Project	<b>IEEE 802.16 Broadband Wireless Access Working Group</b> < <a href="http://ieee802.org/16">http://ieee802.org/16</a> >	
Title	<b>DL and UL loading parameters information</b>	
Date Submitted	<b>2007-02-18</b>	
Source(s)	Peretz Feder – Alcatel-Lucent Phillip Barber - Huawei Honghai Zhang – Alcatel-Lucent	<a href="mailto:pfeder@alcatel-lucent.com">pfeder@alcatel-lucent.com</a> <a href="mailto:pbarber@broadbandmobiletech.com">pbarber@broadbandmobiletech.com</a> <a href="mailto:hozhang@alcatel-lucent.com">hozhang@alcatel-lucent.com</a>
Re:	IEEE 802.16 Session #47 plus – Phone CBR session	
Abstract	This contribution proposes the updates of IEEE 802.16g D7 document in order to obtain loading information from the Base Station	
Purpose	Update 802.16g draft obtain uplink and downlink loading information	
Notice	This document has been prepared to assist IEEE 802.16. It is offered as a basis for discussion and is not binding on the contributing individual(s) or organization(s). The material in this document is subject to change in form and content after further study. The contributor(s) reserve(s) the right to add, amend or withdraw material contained herein.

## **DL and UL loading

Figure - 57 Maintaining downlink synchronization

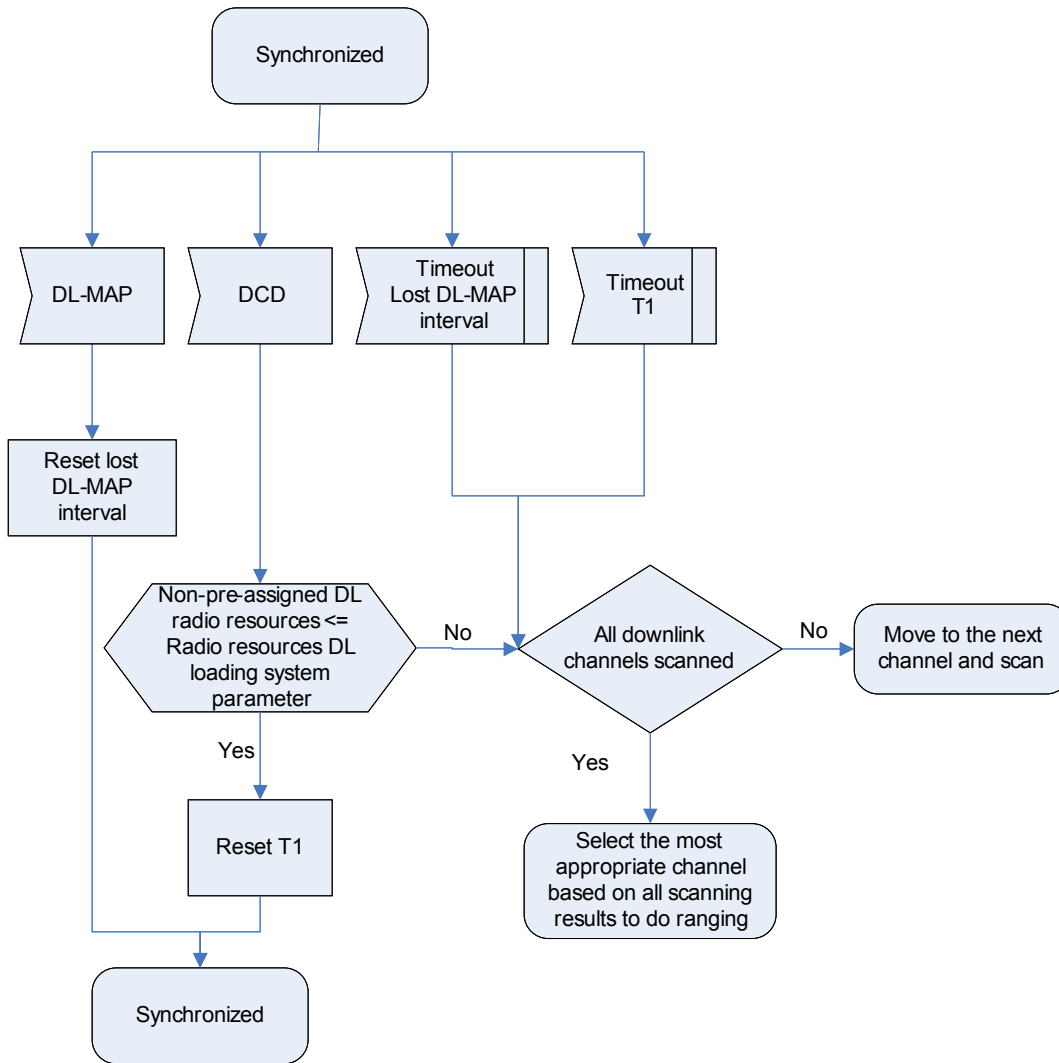
The MAC shall search for the DL-MAP MAC management messages. The SS achieves MAC synchronization once it has received at least one DL-MAP message and is able to decode the DL-Burst Profiles contained therein. An SS MAC remains in synchronization as long as it continues to successfully receive the DL-MAP and DCD messages for its Channel and the Non-pre-assigned DL radio resources in the DCD message are higher than the Radio\_resources DL loading\_system\_paramater. If the reported Non-pre-assigned DL radio resources are less than the “Radio\_resources DL loading\_system\_paramater” threshold the SS/MS should continue scanning to find another channel until all channels are scanned. If all channels are scanned, the MS should choose the most appropriate channel to perform initial ranging according to section 6.3.9.5 based on conditions that include RSSI, CINR and the available Non-pre-assigned DL/UL radio resources of all channels. If the Lost DL-MAP Interval (Table 342) has elapsed without a valid DL-MAP message or the T1 interval (Table 342) has elapsed without a valid DCD message, an SS shall try to reestablish synchronization. The process of acquiring synchronization is illustrated in Figure 56. The process of maintaining synchronization is illustrated in Figure 57. (language change: add MS and SS section to explain better – perform MAC HO function 6.3.25 or 22?. SS initial entry )

(Note to Editor: Need to modify Figure 57 – see below)

Figure 58 – Obtaining uplink Parameters

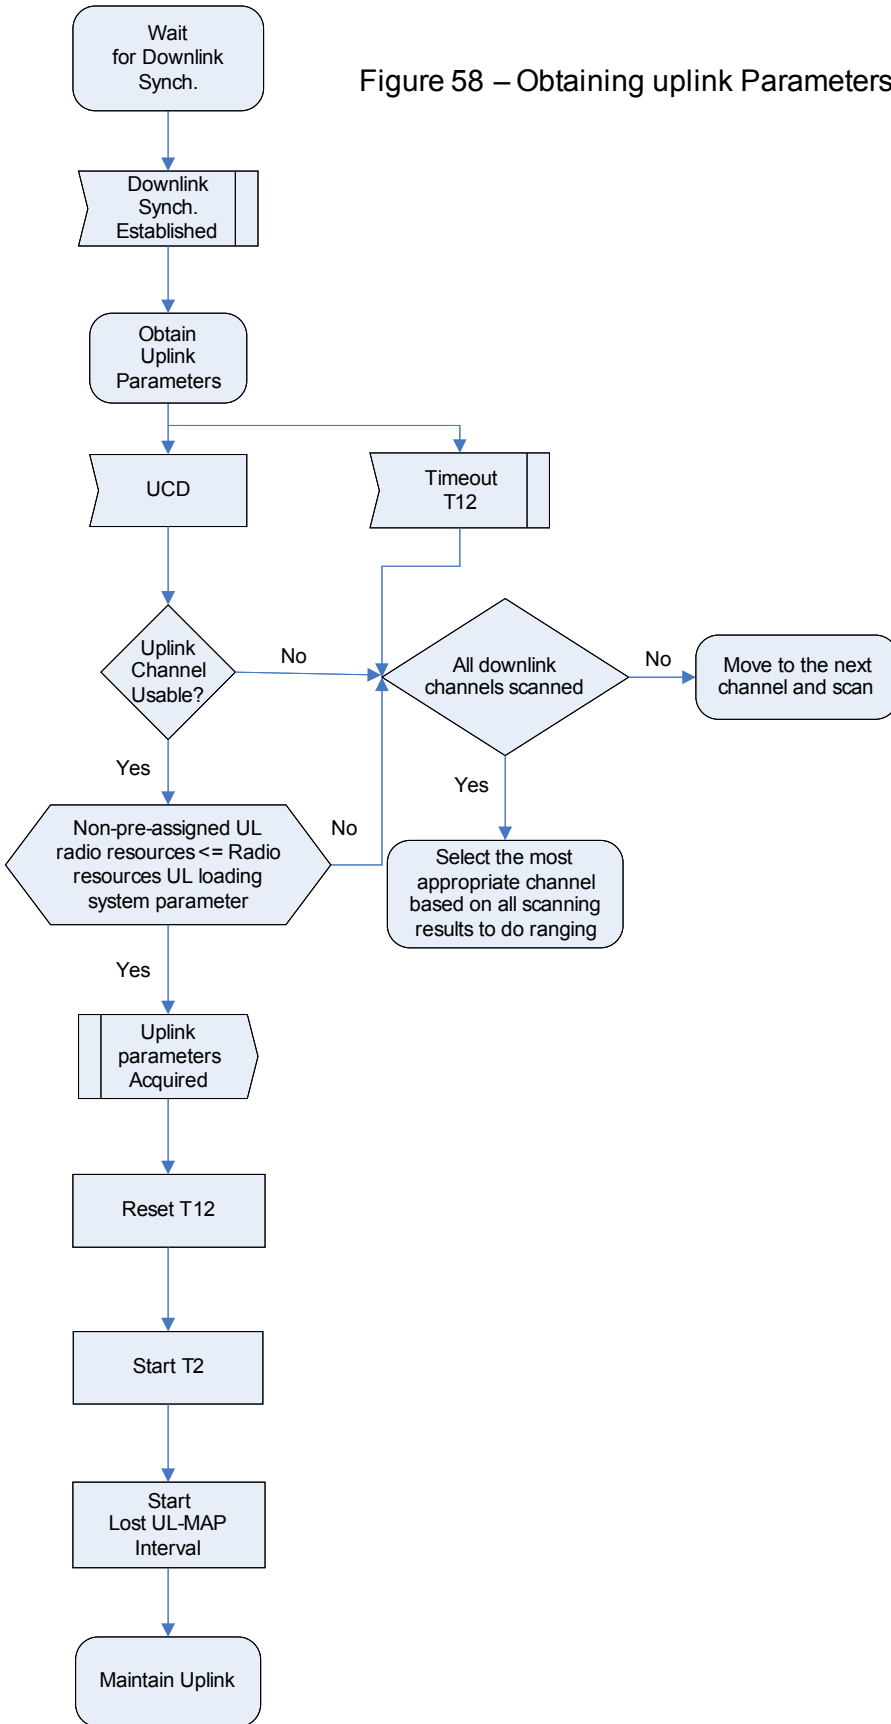
If no uplink can be found after a suitable timeout period, or if the Non-pre-assigned UL radio resources in the UCD message are lower than the Radio\_resources\_UL\_loading\_system\_paramater then the SS shall continue scanning to find another downlink channel. The process of obtaining uplink parameters is illustrated in Figure 58. (Editor: need to change Figure 58 – see below)
